| Project | IEEE 802.16 Broadband Wireless Access Working Group < http://ieee802.org/16 > | |
| Title | Credit token based coexistence protocol text update | |
| Re: | IEEE 80216h-07/013 Task Group Review of P802.16h/D2b | |
| Purpose | Consolidation of draft D2b text on credit token based coexistence protocol | |

Figure h57: Whole CT-CXP Procedure

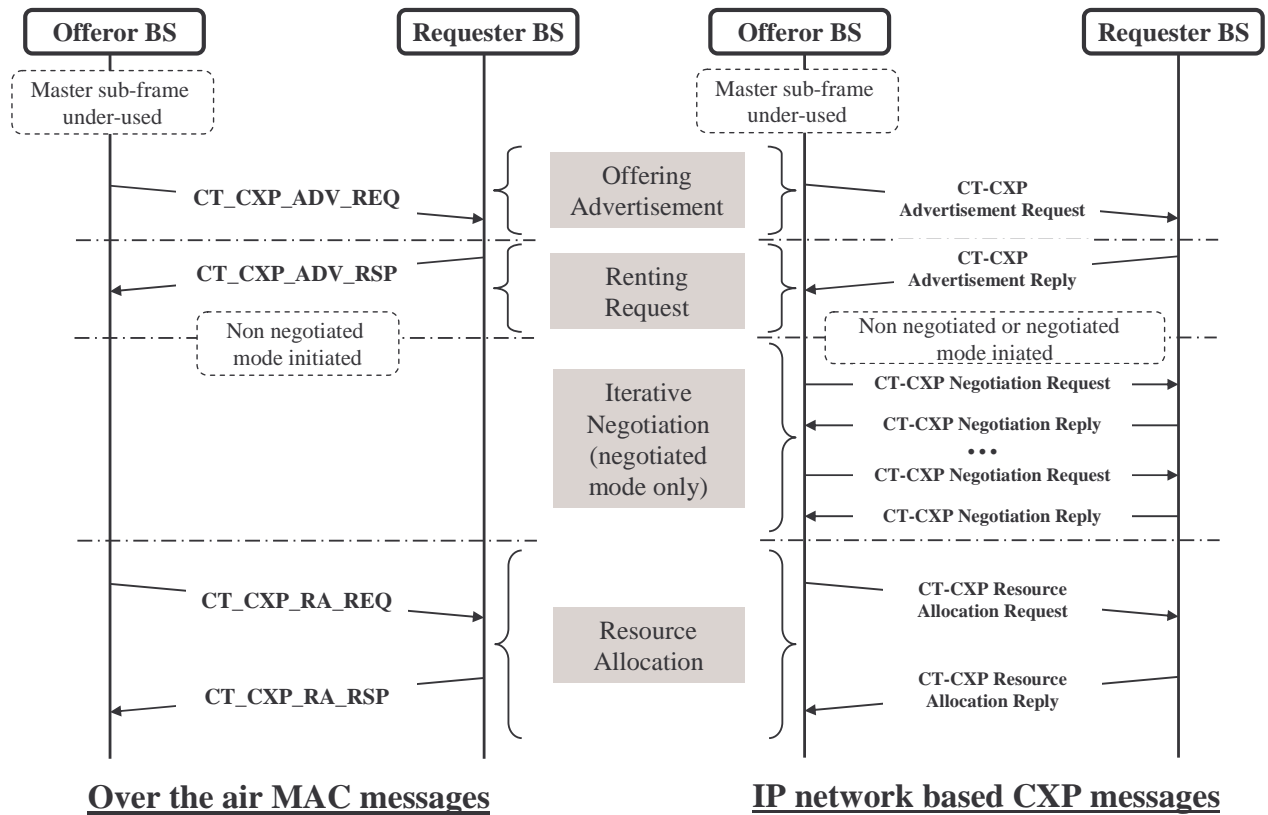
[Replace Figure h61 with the following updated one as indicate:]

CT-CXP is composed of several consecutive procedures (offering advertisement, renting request, iterative negotiation, and resource allocation) as shown in *Figure h57*. For the sake of simplicity, this figure is only depicted for one (among multiple) requesters. Over the air based instantiation of CT-CXP for the non negotiated mode is depicted on the left hand side of *Figure h57*. The over IP network based instantiation of CT-CXP for the negotiation or non negotiated mode is depicted on the right hand side of *Figure h57*. MAC messages related to the over the air instantiation are specified in section ~~6.3.2.3~~^{15.3.2.3}. Inter system over the air communications mechanisms are described in subclause 15.6. CXP messages related to IP network based instantiation are specified in section 15.5.1. The offering advertisement message (CT-CXP Advertisement Request) specifies which negotiation mode is used by the CT-CXP. The iterative negotiation procedure is executed only with the negotiated mode and not with the non-negotiated mode.

Figure h58: Over the air based CT-CXP offering procedure

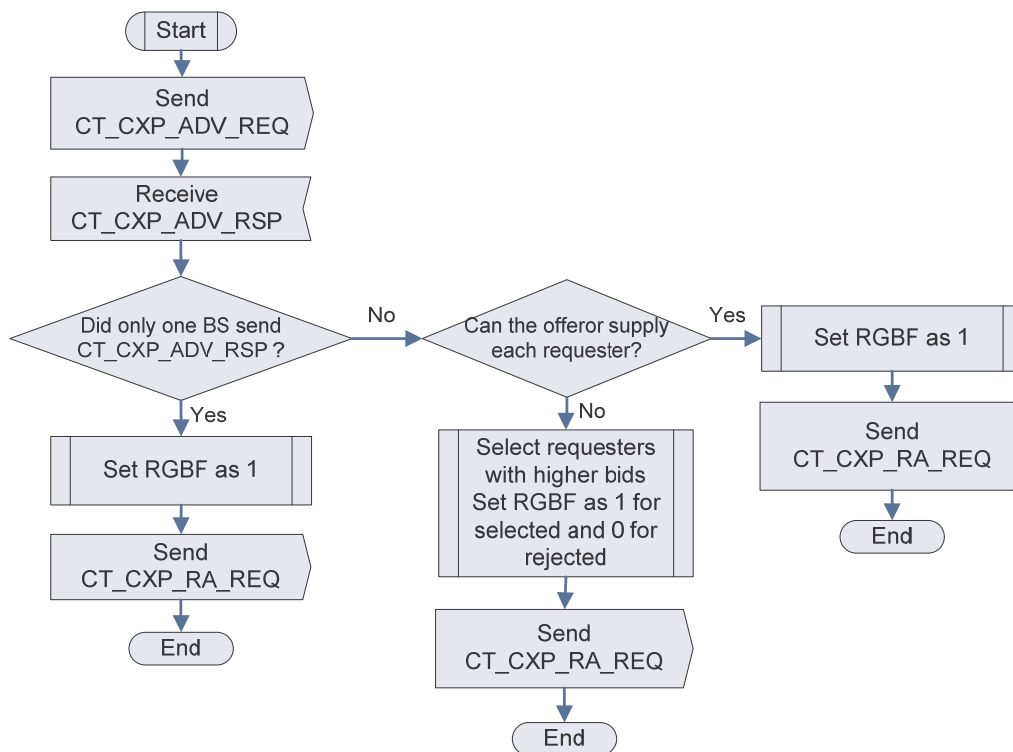
[Replace Figure h58 with the following updated one as indicate:]

a) The procedure described in *Figure h58* is as follows:

- A BS identifies that a part of its master subframe is going to be under-used and can be rented out. With respect to this, this BS becomes an offeror BS and initiates the renting advertisement by broadcasting the `CT_CXP_ADV_REQ` message. In particular, this message includes information related to the available resource (T_renting_subframe, Renting_out_start_time, Renting_out_end_time) as well as the renting conditions (MNCT: Minimum number of credit tokens per resource unit required per requester's bid), and also a list (LC: List of Channels) of other channels (frequency domain) proposed by the offeror BS for renting.

- If the offeror BS receives one single `CT_CXP_ADV_RSP` message, then the offeror BS grants the renting resource to the single requester by setting the Resource Granting Bit Flag (RGSF) to 1 in the `CT_CXP_RA_REQ` message. The granted requester is not charged with credit token since it is not competing with some other requesters.

- If the offeror BS receives more than one CT_CXP_ADV_RSP message, then it assesses whether he can supply each requester or not:
 - If it can supply, the offeror BS grants the renting resource to all requesters by setting the Resource Granting Bit Flag (RGBF) to 1 in the CT_CXP_RA_REQ message.

- If it cannot, the offeror BS derives and selects requesters with higher bids based on the information received from competing requesters. The offeror BS grants the resource to the selected requesters by setting the Resource Granting Bit Flag (RGBF) to 1 in the CT_CXP_RA_REQ message. These selected requesters can access to their requested resource Rented_resource_amount from Renting_subframe_start_time to Renting_subframe_end_time during the guaranteed requested time period (Renting_in_start_time, and Renting_in_end_time). RGBT is set to 0 for the non selected requesters.

- The CT_CXP_RA_REQ message includes the clearing price (Clearing_price), ~~mentioning the number of credit tokens the requester has to freeze to acquire the granted resource.~~ Derived from the selection process, the clearing price corresponds to the number of credit tokens per RRU that has to be considered in the pricing method specified within PBF of CT-CXP Advertisement Request message.

Figure h59: IP network based CT-CXP offering procedure

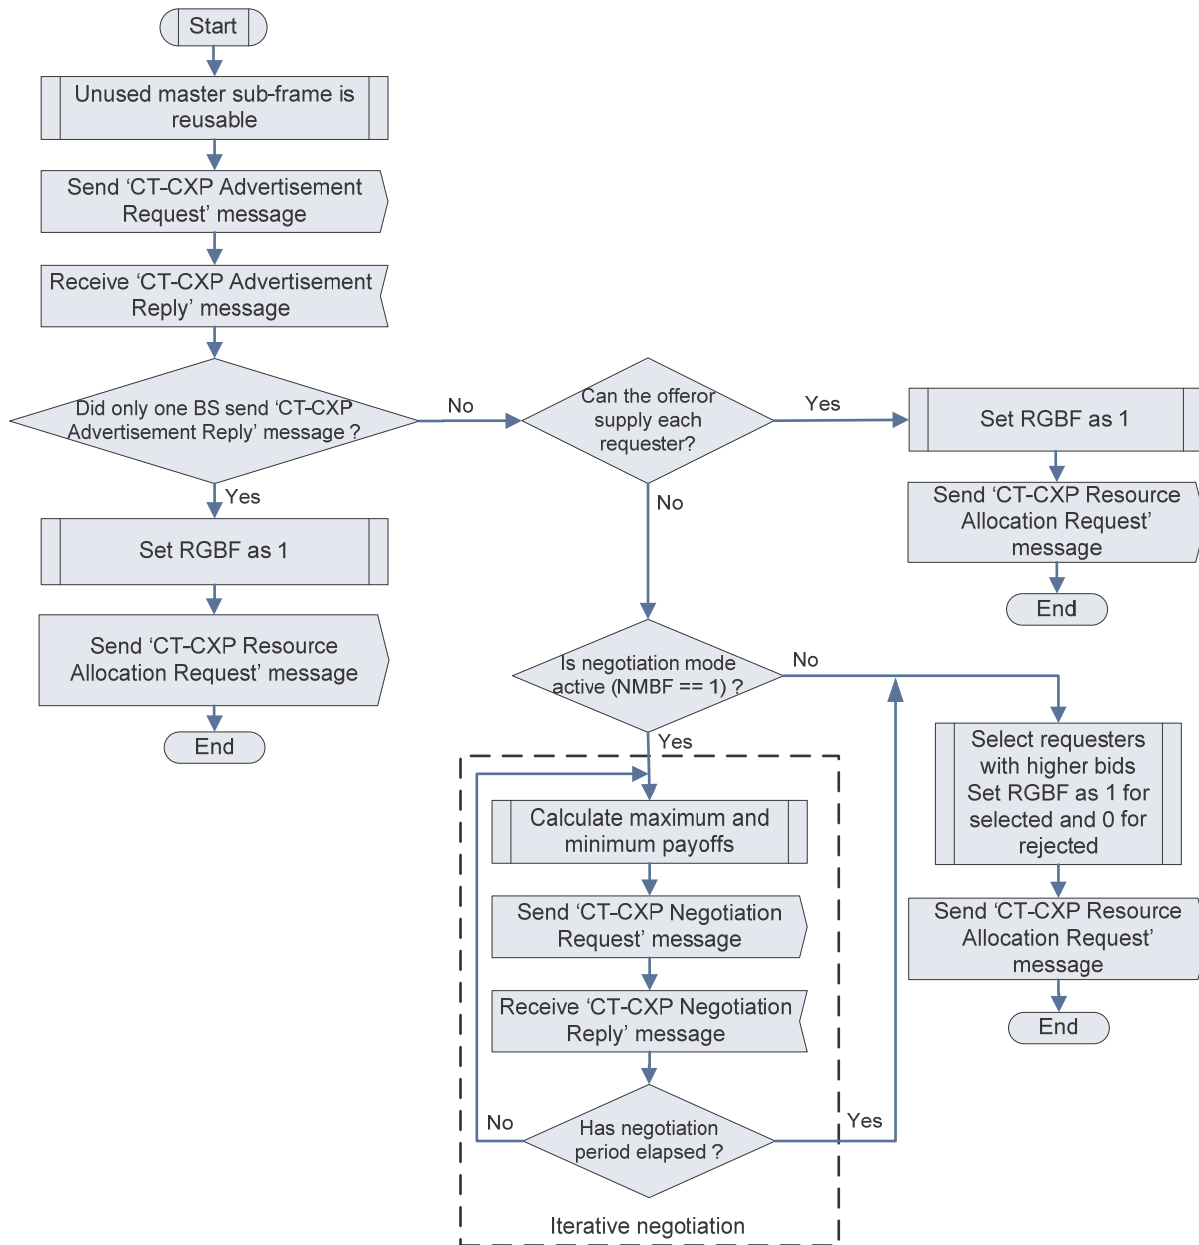
[Replace Figure h59 with the following updated one as indicate:]

b) The procedure described in Figure h59 is as follows:

- A BS identifies that a part of its master subframe is going to be under-used and can be rented out. With respect to this, this BS becomes an offeror BS and initiates the renting advertisement by broadcasting the “CT-CXP Advertisement Request” message. In particular, this message includes information related to:
 - The available resource (T_renting_subframe, Renting_out_start_time, Renting_out_end_time),

- The negotiation mode (NMBF == 0: non negotiated mode is active, NMBF == 1: negotiated mode is active),
- The renting conditions (Start_negotiation_time, End_negotiation_time, MNCT, LC),

- The pricing method in case NMBF~~NMFF~~ == 1.
- If the offeror BS receives one single “CT-CXP Advertisement RRequest” message, then the offeror BS grants the renting resource to the single requester by setting the Resource Granting Bit Flag (R~~GBF~~) to 1 in the “CT-CXP RResource AAllocation Request” message. The granted requester is not charged with credit token since it is not competing with some other requesters.

- If the offeror BS receives more than one “CT-CXP Advertisement RRequest” message, then it assesses whether he can supply each requester or not:
 - If it can supply, the offeror BS grants the renting resource to all requesters by setting the Resource Granting Bit Flag (R~~GBF~~) to 1 in the “CT-CXP RResource AAllocation Request” message.

- If it cannot, the offeror BS follows the negotiated mode under consideration:
 - If NMBF == 0, same procedure as a) is executed. The offeror BS derives and selects requesters with higher bids based on the information received from competing requesters. The offeror BS grants the resource to the selected requesters by setting the Resource Granting Bit Flag (R~~GBF~~) to 1 in the “CT-CXP RResource AAllocation Request” message. These selected requesters can access to their requested resource Rented_resource_amount from Renting_subframe_start_time to Renting_subframe_end_time during the guaranteed requested time period (Renting_in_start_time, and Renting_in_end_time). R~~GBT~~ is set to 0 for the non selected requesters.

- If NMBF == 1, iterative negotiation occurs between the offeror BS and each requester BS. Based on the information received within the “CT-CXP Advertisement RReply” message, the offeror BS calculates respectively a minimum and maximum payoff (Minimal_payoff and Maximal_payoff) at each iteration. These payoffs allow selecting the remaining requesters at each iteration. An example of payoff calculation is given in section 15.4.2.4.2. At each iteration, Minimal_payoff and Maximal_payoff are sent within the “CT-CXP Negotiation Request” message. The iterative negotiation occurs until the negotiation period (bounded by End_negotiation_time) is elapsed. At the end of the negotiation, the final requesters are selected by the offeror BS. The offeror BS grants the resource to the selected requesters by setting the Resource Granting Bit Flag (R~~GBF~~) to 1 in the “CT-CXP RResource AAllocation Request” message. These selected requesters can access to their requested resource Rented_resource_amount from Renting_subframe_start_time to Renting_subframe_end_time during the guaranteed requested bounded time period (Renting_in_start_time, and Renting_in_end_time). R~~GBT~~ is set to 0 for the non selected requesters.

Figure h60: Over the air based CT-CXP requesting procedure

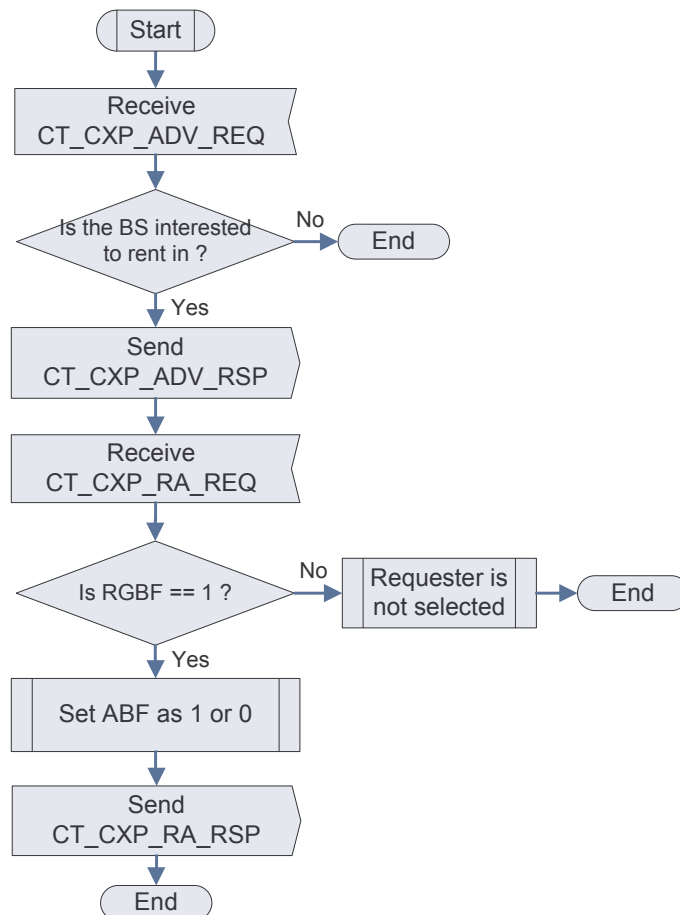
[Replace Figure h60 with the following updated one as indicate:]

a) The procedure described in *Figure h60* is as follows:

- If a BS is in need of additional resource and can meet MNCT requirements, he can make a request (CT_CXP_ADV_RSP message) upon the reception of CT_CXP_ADV_REQ.

- Within CT_CXP_ADV_RSP, the requester informs about the amount of required resource (Rented_resource_amount), the rented in start and end time (Renting_in_start_time, Renting_in_end_time) and the requester's bid (Requester_bid) in term of number of credit tokens bidded per renting resource unit (RRU).

- Upon reception of CT_CXP_RA_REQ message, the requester BS knows whether it has been selected or not. If RGBF is set to 1, the requester BS is selected, otherwise (RGBF set to 0) the requester is rejected.

- The requester decides to accept (Acceptation Bit Flag ABF set to 1) or to reject (ABF set to 0) the resource granting based on the Clearing_price information. This information is sent within the CT_CXP_RA_RSP message.

- If ABF is set to 1, a number of credit tokens equal to $\frac{\text{Clearing_price} * \text{Rented_resource_amount} * T_{\text{renting_subframe}}}{[\text{Renting_in_end_time} - \text{Renting_in_start_time}] / \text{CX_Frame_duration} / \text{RRU_duration}}$ ~~the clearing price~~ will not be usable (for some ~~further~~~~other~~ renting requests by this same requester) for a time duration equal to $[\# \text{Renting_in_start_time}; \# \text{Renting_in_end_time} + \delta]$ where δ is a frozen period margin. This ensures fairness over time between competing requester BSs to access to some other renting offers.

Figure h61: IP network based CT-CXP requesting procedure

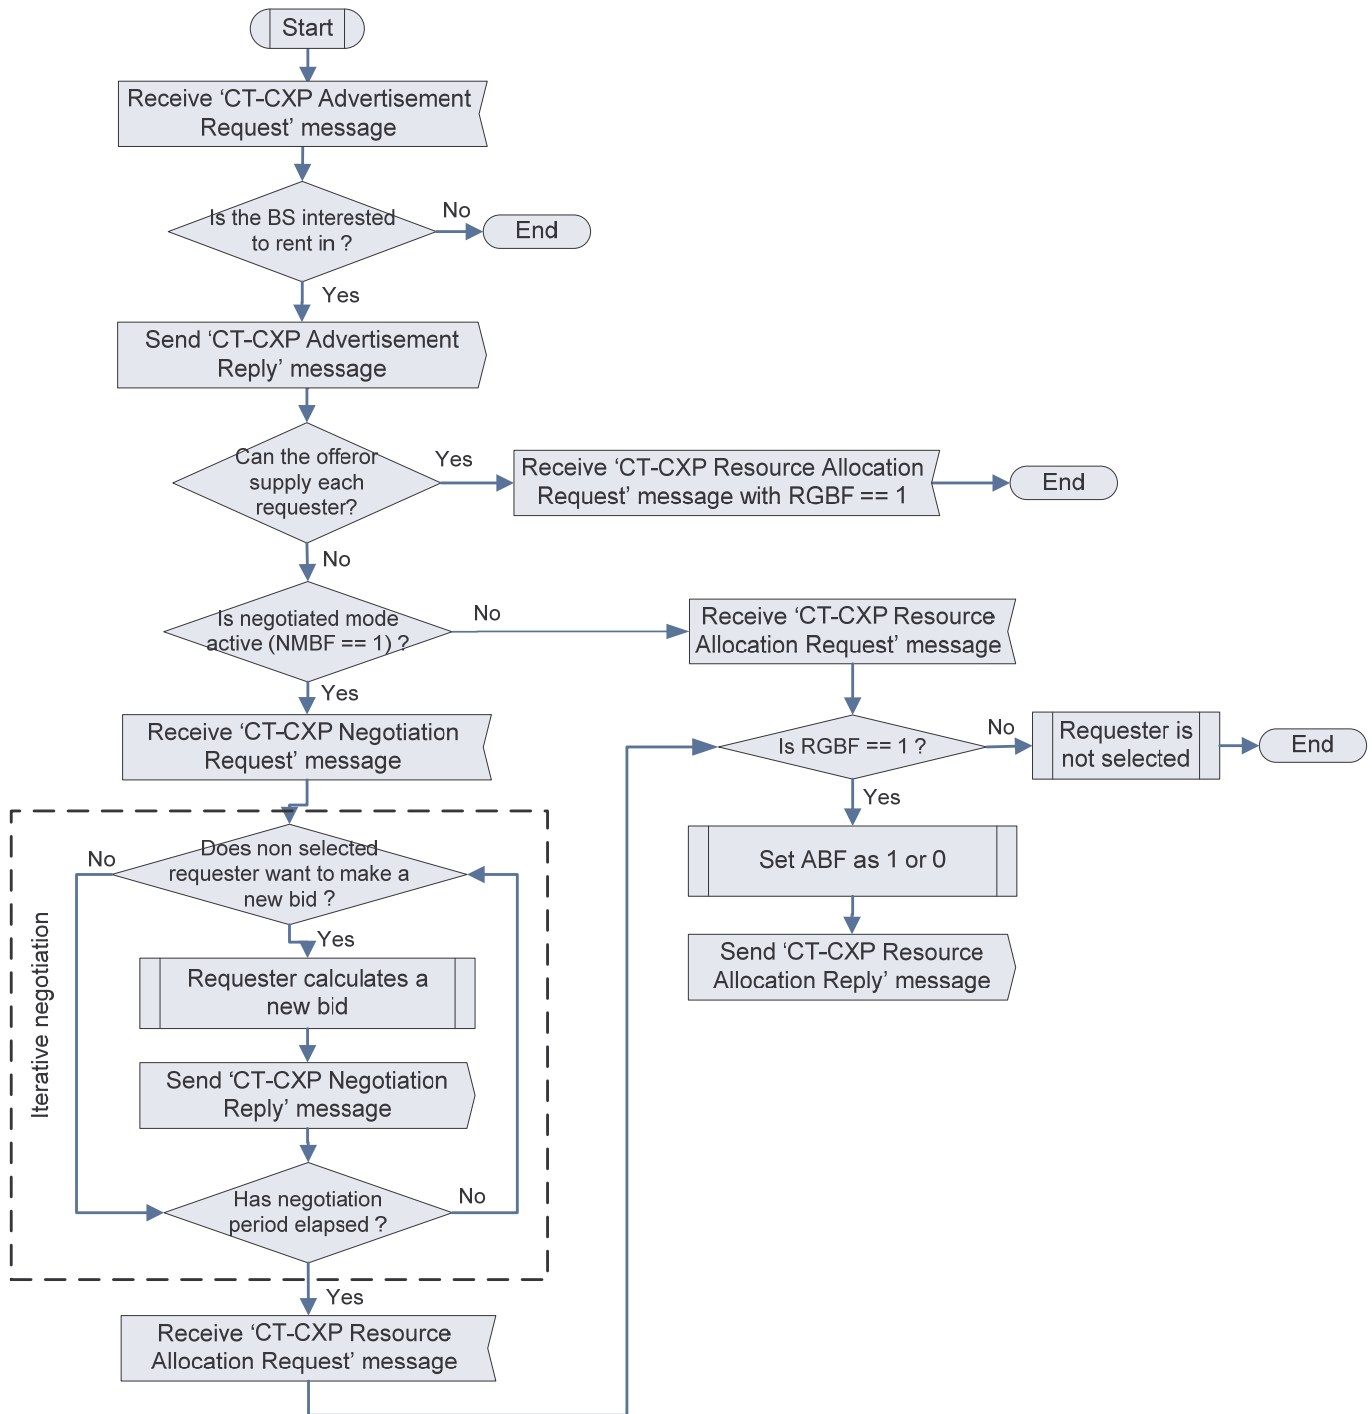
[Replace Figure h61 with the following updated one as indicate:]

b) The procedure described in Figure h61 is as follows:

- If a BS is in need of additional resource, meets MNCT requirements, and agrees with the proposed negotiation mode (NMBF) and pricing method (PBF) specified within the “CT-CXP Advertisement Request” message, he can submit a bid (within “CT-CXP Advertisement Reply” message) upon the reception of the “CT-CXP Advertisement Request” message.

- Within the “CT-CXP Advertisement Reply” message, the requester informs about the amount of required resource (Rented_resource_amount), the rented in start and end time (Renting_in_start_time, Renting_in_end_time) and ~~the requester's~~ its bid (Requester_bid) in term of number of credit tokens bidded per renting resource unit (RRU).

- If the non negotiation mode is active (NMBF == 0), same procedure as a) is executed. If the offeror BS can supply to the requester BS, the offeror BS grants the renting resource by setting the Resource Granting Bit Flag (RGBF) to 1 in the “CT-CXP Resource Allocation Request” message.

- If the negotiation mode is active (NMBF == 1), iterative negotiation occurs between the offeror BS and each requester BS. At each iteration, based on the information Minimum_payoff and Maximal_payoff received from the “CT-CXP Negotiation Request” message, the requester decides to submit a new bid (Requester_bid_update) or not. Requester_bid_update is sent within the “CT-CXP Negotiation Reply” message. The iterative negotiation occurs until the negotiation period (bounded by End_negotiation_time) is elapsed.

- Upon reception of the “CT-CXP Resource Allocation Request” message, the requester BS knows whether it has been selected or not. If RGBF is set to 1, the requester BS is selected, otherwise (RGBF set to 0) the requester is rejected.

- The requester decides to accept (Acceptation Bit Flag ABF set to 1) or to reject (ABF set to 0) the resource granting based on the Clearing_price information. This information is sent within the “CT-CXP Resource Allocation Reply” message. The method to derive the clearing price is open for the implementation.

- If ABF is set to 1:
 - If PBF == 0, a number of CTs equal to ~~the~~ $\text{Clearing_price} \times \text{Rented_resource_amount} \times \text{T_renting_subframe} \times [(\text{Renting_in_end_time} - \text{Renting_in_start_time}) / \text{CX_Frame_duration}] / \text{RRU_duration}$ is transferred from the requester's ownership to the offeror's one. This calculation is an example and it is open for implementation.

- If PBF == 1, the CT are not transferred but remains to the requester ownership. However, a number of credit tokens equal to the ~~clearing price previous number~~ (as calculated in the previous bullet point) will not be usable (for some ~~other further~~ renting requests by this same requester) for a time duration equal to [Requester's Renting_in_start_time; Requester's Renting_in_end_time + δ] where δ is a frozen period margin. This ensures fairness over time between competing requester BSs to access to some other renting offers.

Figure h64—Inter system over the air communications messages for CT-CXP operations

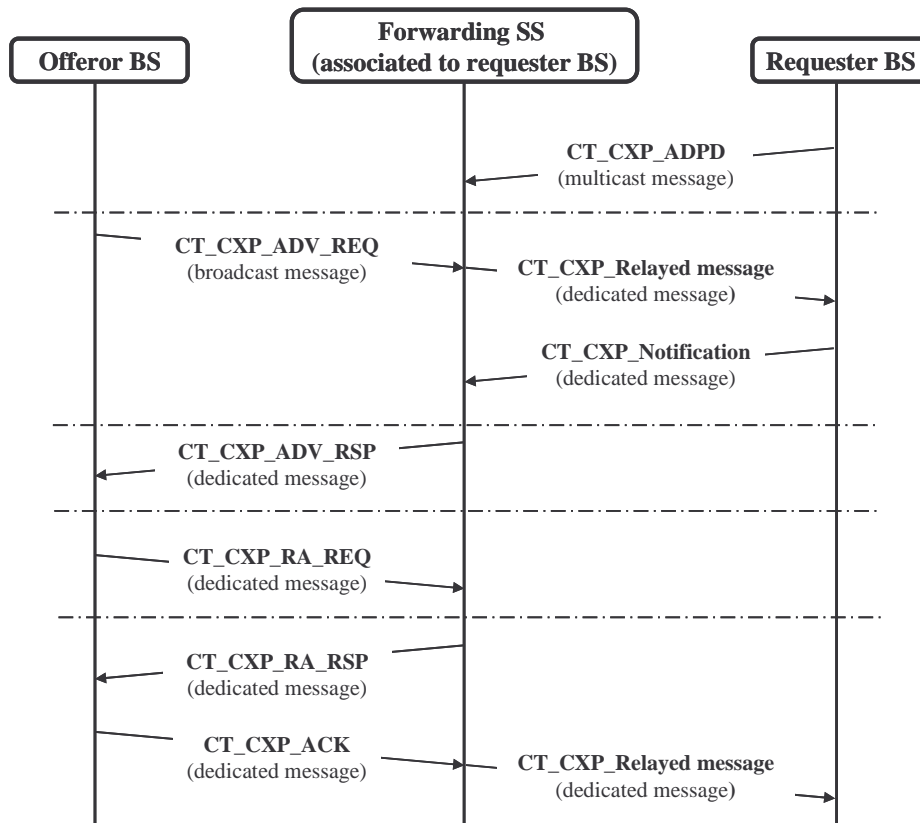
[Replace Figure h64 with the following updated one as indicate:]

Figure h64 describes the over the air communications messages between the offeror and requester for CT-CXP operations. The messages between the offeror BS and requester BSs are conveyed through SS(s) acting as forwarder~~relay~~ between the offeror and requester BSs. Each forwarding~~relaying~~ SS is associated to the requester BS and is in the overlapping coverage of the offeror and requester BSs. The forwarding~~relaying~~ SS can receive and decode messages from both its serving BS (requester BS) and the foreign BS (offeror BS), and can send transmit message to both offer or and requester BS.
